CITY OF BOULDER
PLANNING BOARD MEETING AGENDA
DATE: August 21, 2014
TIME: 6 p.m.
PLACE: Council Chambers, 1777 Broadway

AGENDA TITLE: Public hearing to consider **Concept Plan**, LUR2014-00045, for the phased redevelopment of the 8.45-acre Armory site located at the southeast corner of Broadway and Lee Hill Dr. with a mixed-use project including the Phase 1 development of the western half of the site with 127 residential units, a 10,700 s.f. arts market/ studio space, 10,900 s.f. of retail/ flex space and up to 13,100 s.f. of restaurant space including a new 9,500 s.f. brew pub to be located in the existing “mess hall” building; and the Phase 2 development of the eastern half of the site with 65 mixed density residential units.

DATE OF COMMENTS: **July 7, 2014**
 CASE MANAGER: **Chandler Van Schaack**
 PROJECT NAME: **The Armory**
 LOCATION: **4750 BROADWAY**
 COORDINATES: **N09W06**
 REVIEW TYPE: **Concept Plan Review & Comment**
 REVIEW NUMBER: **LUR2014-00045**
 APPLICANT: **LIZ PETERSEN**

DESCRIPTION: **CONCEPT PLAN REVIEW AND COMMENT for the Armory. Proposal is for the development of a new mixed-use project with mixed density residential and non-residential uses. Includes t

Addendum: Preliminary Street Sections

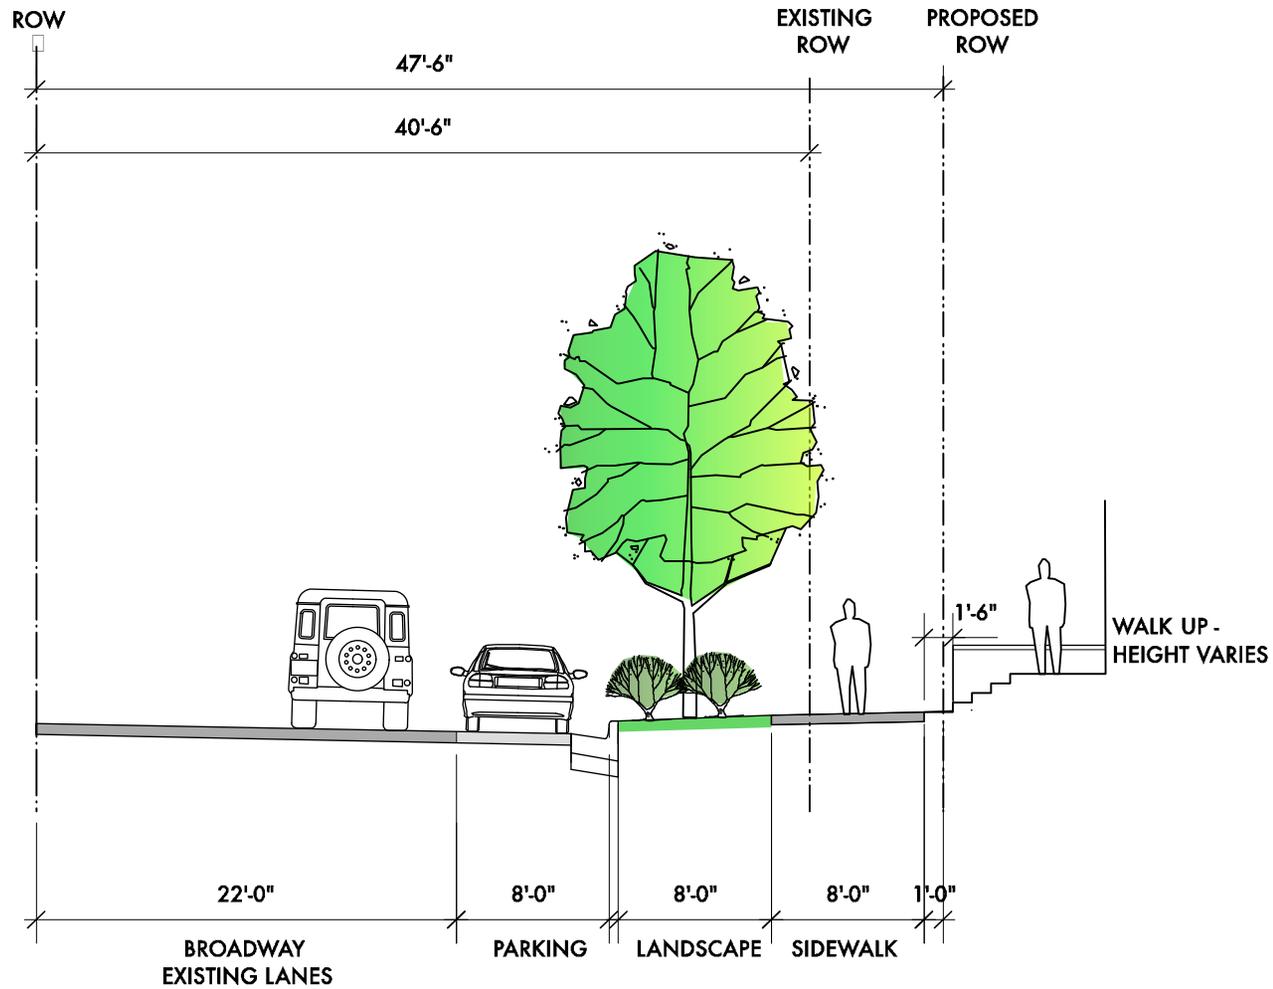
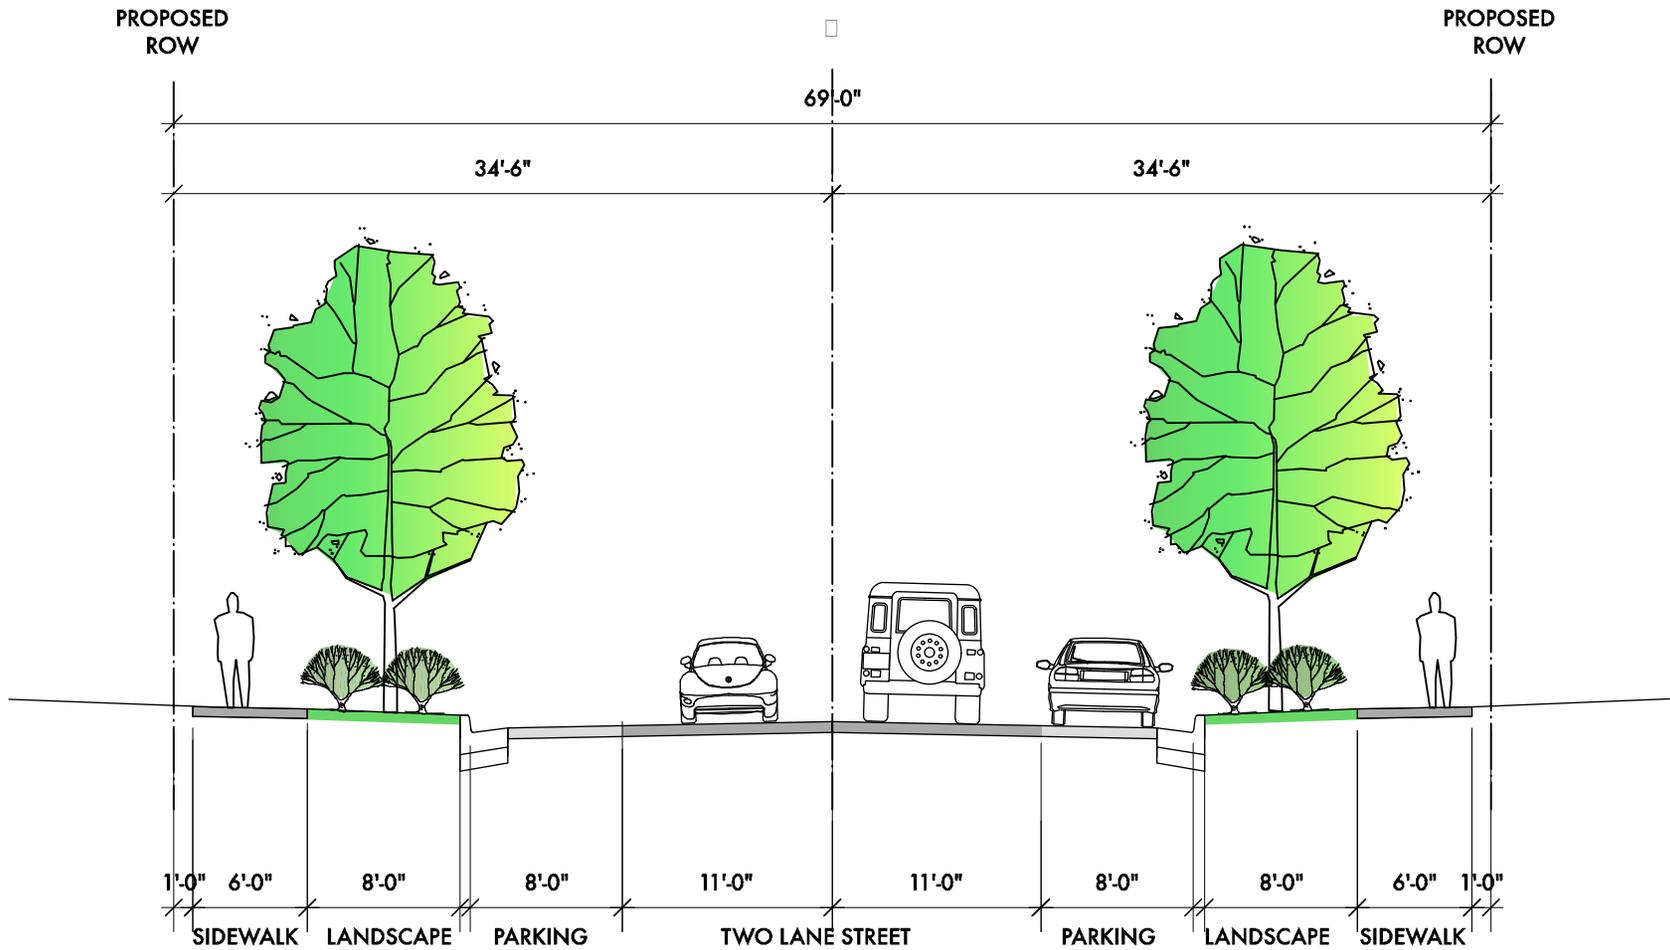
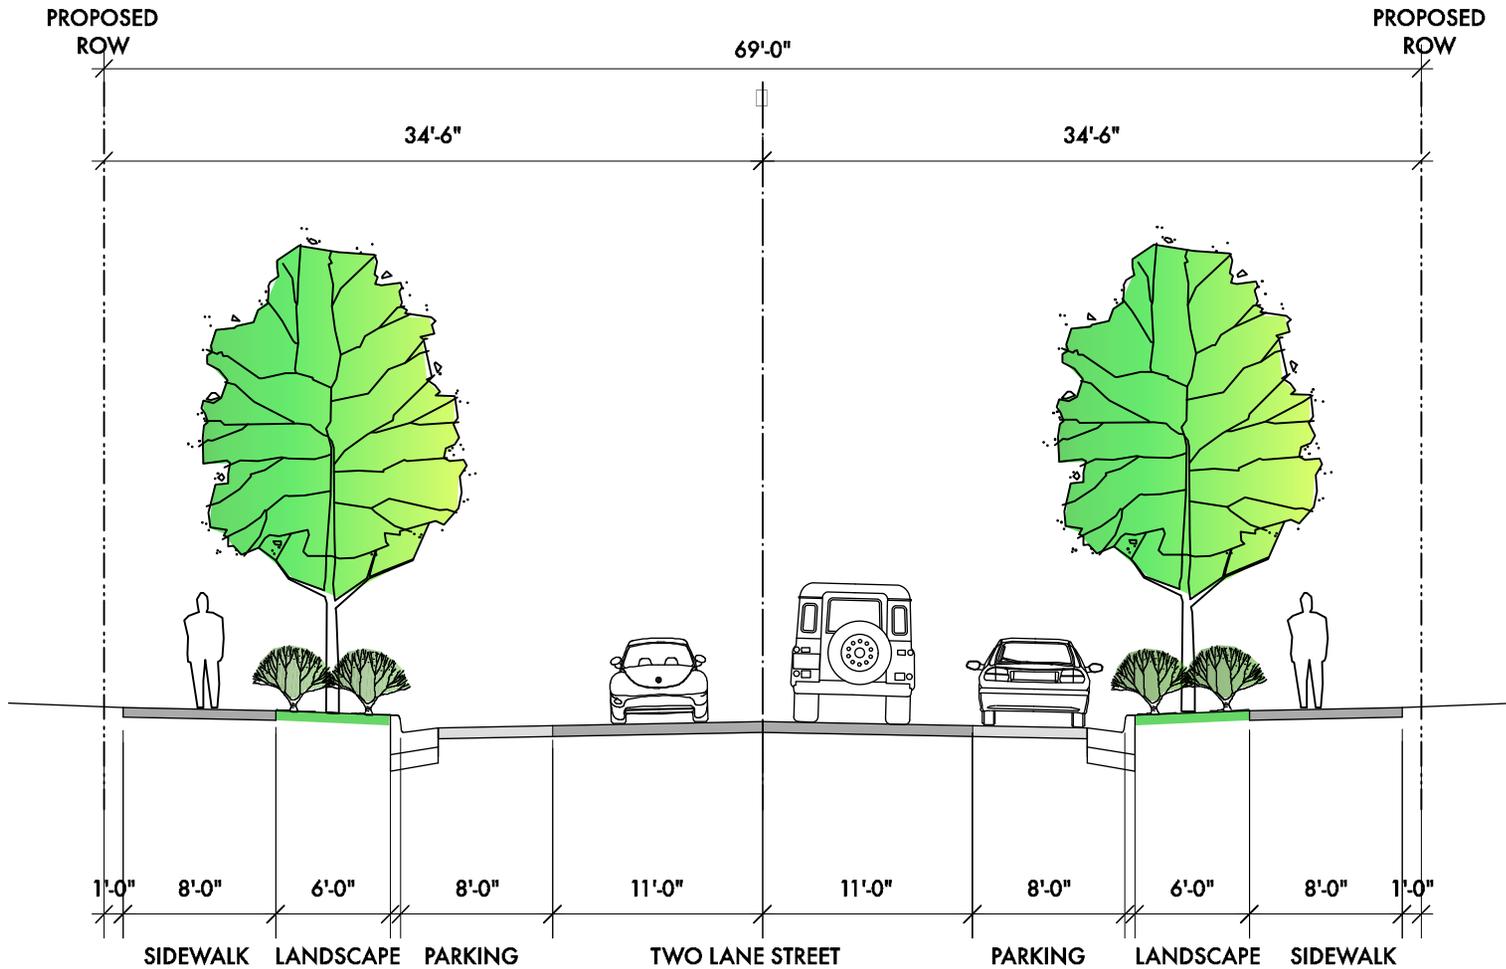
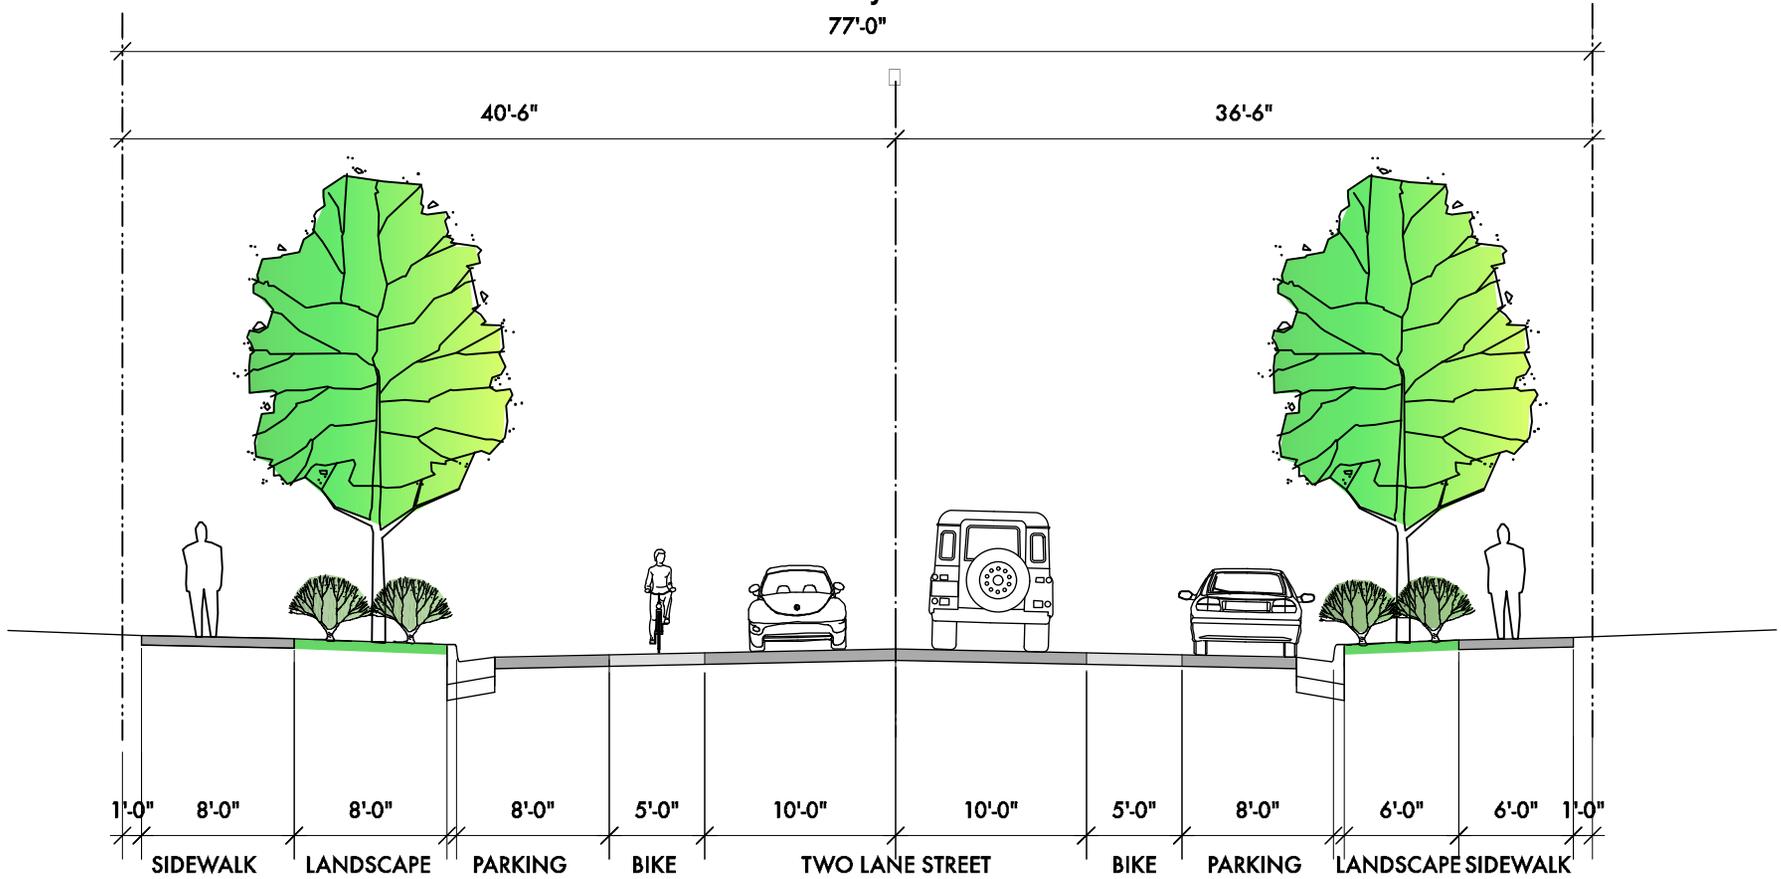
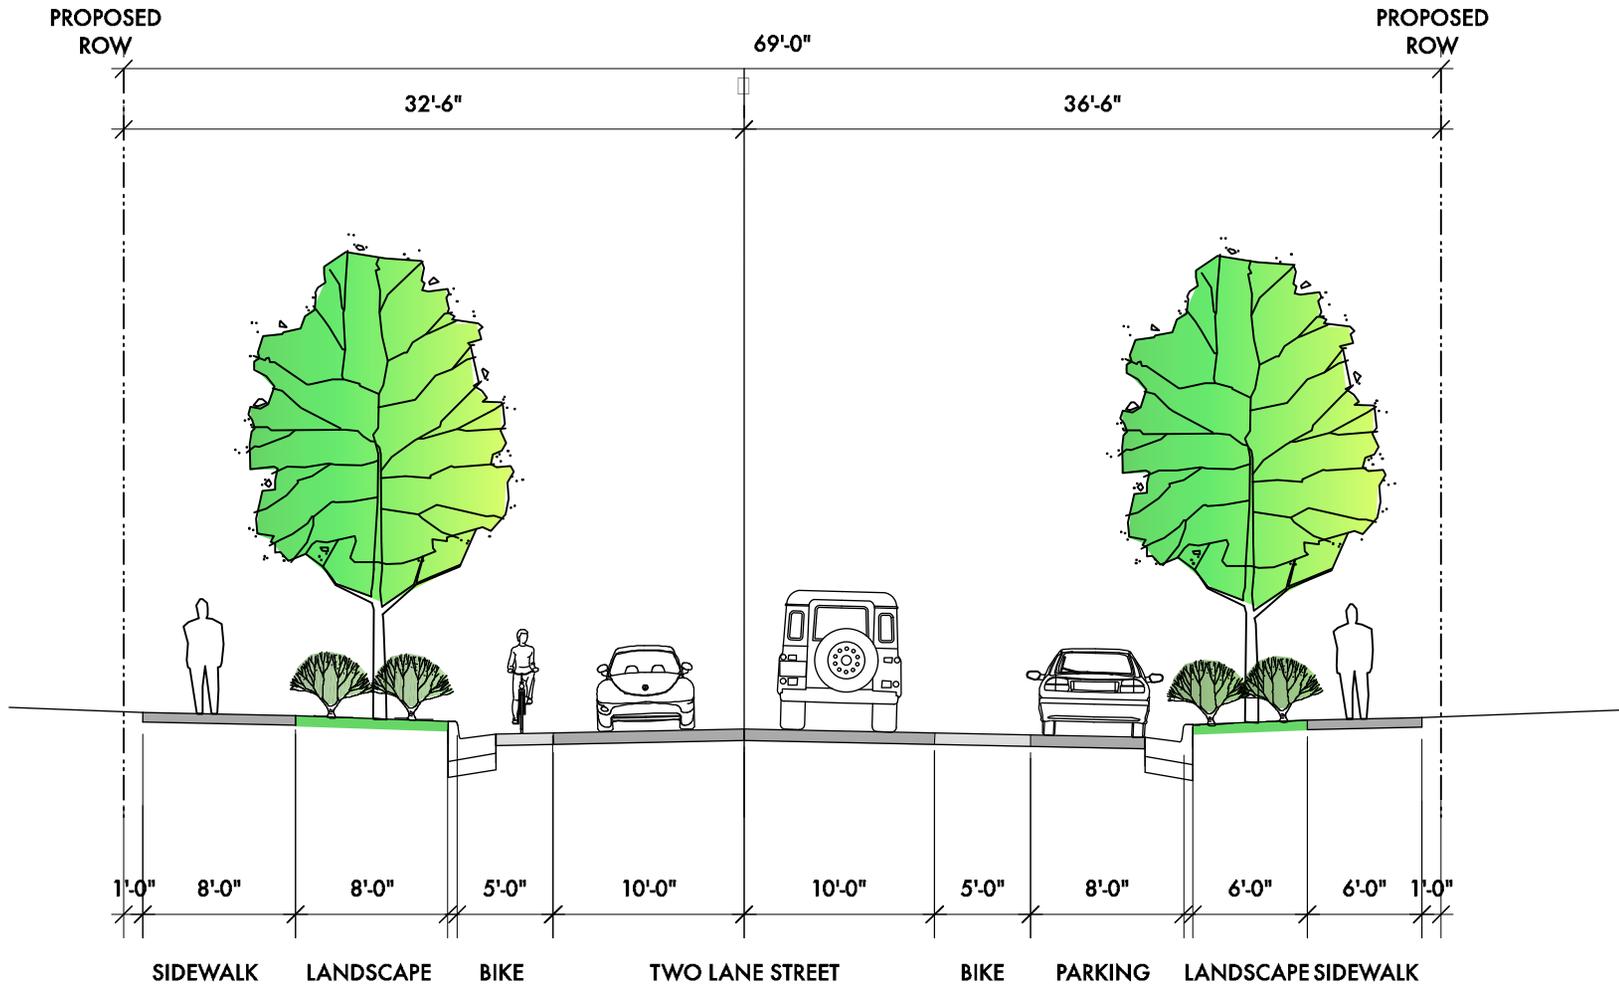
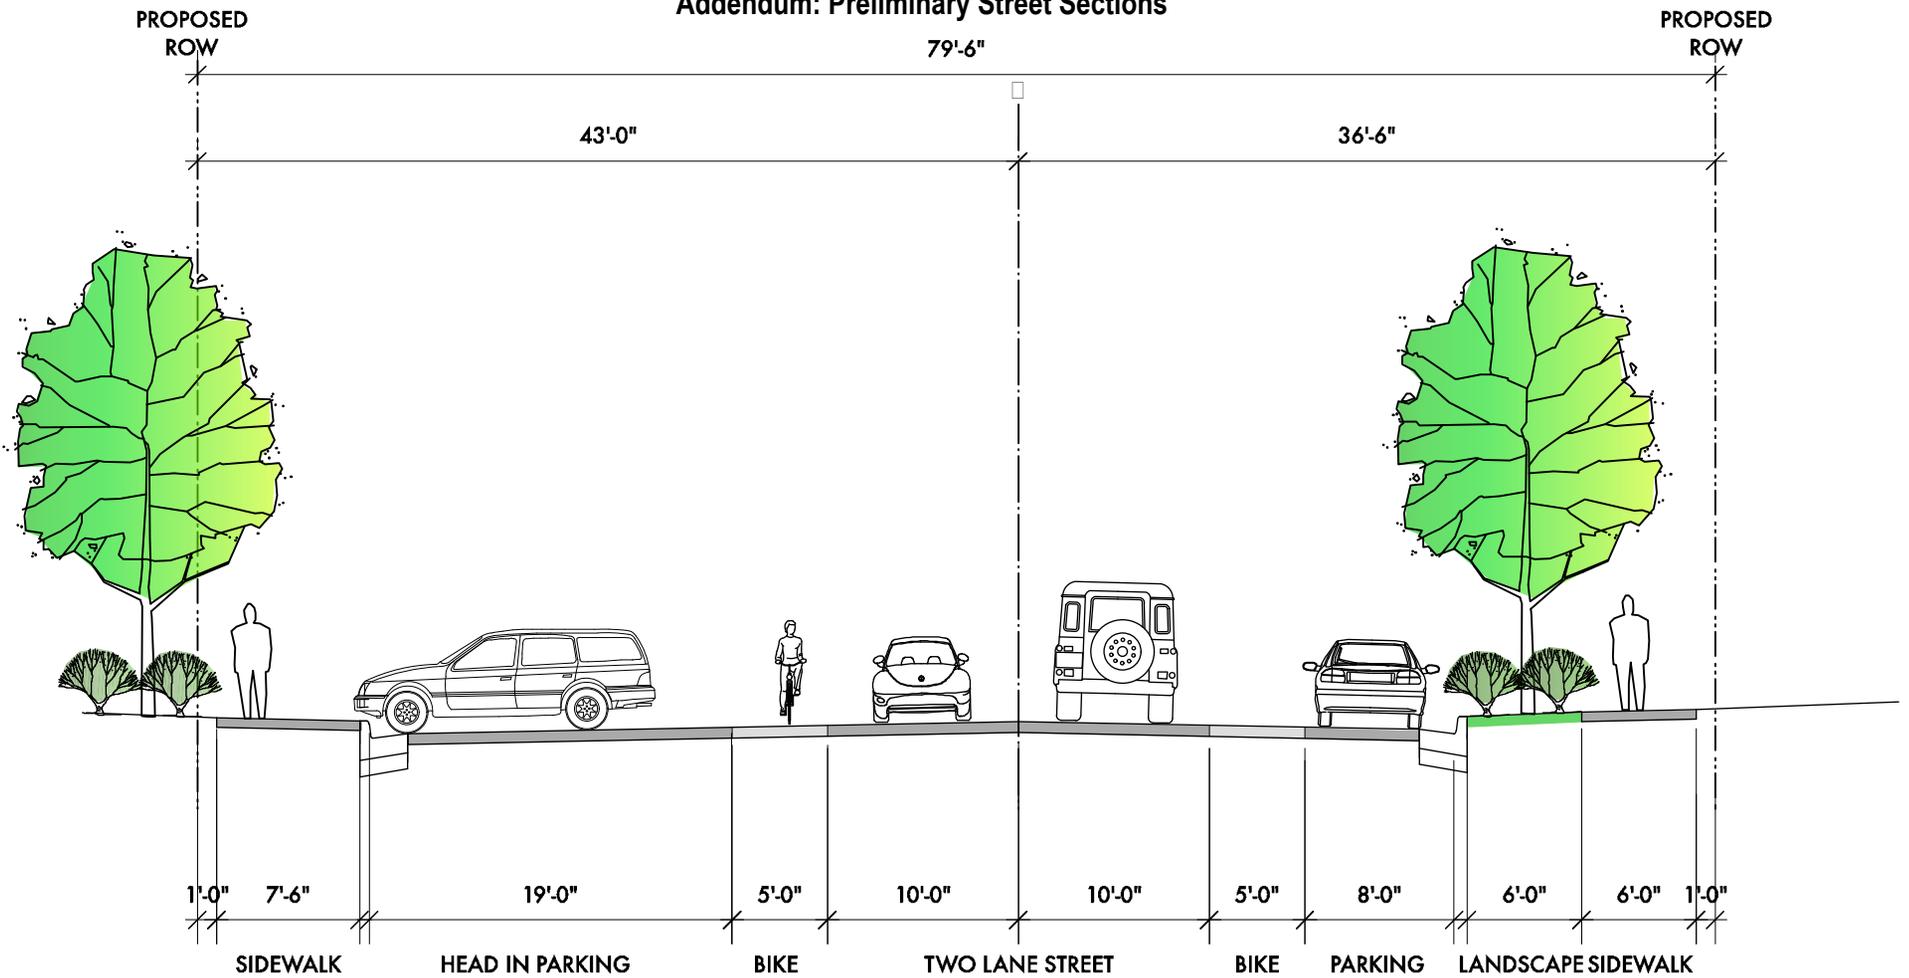
Overall, the proposed streets through the site are consistent with the NoBo Plan and will serve to enhance connectivity in the area and potentially reduce traffic on Broadway. The proposed street sections appear to be consistent with previous discussions with the applicant. Staff has some concerns regarding the alignment of the access points on Broadway and Lee Hill, which are outlined in further detail below.

6. Pursuant to section 9-9-15 of the Boulder Revised Code, 1981 eighteen inches of separation needs to be provided between the edge of walk and any proposed retaining wall.
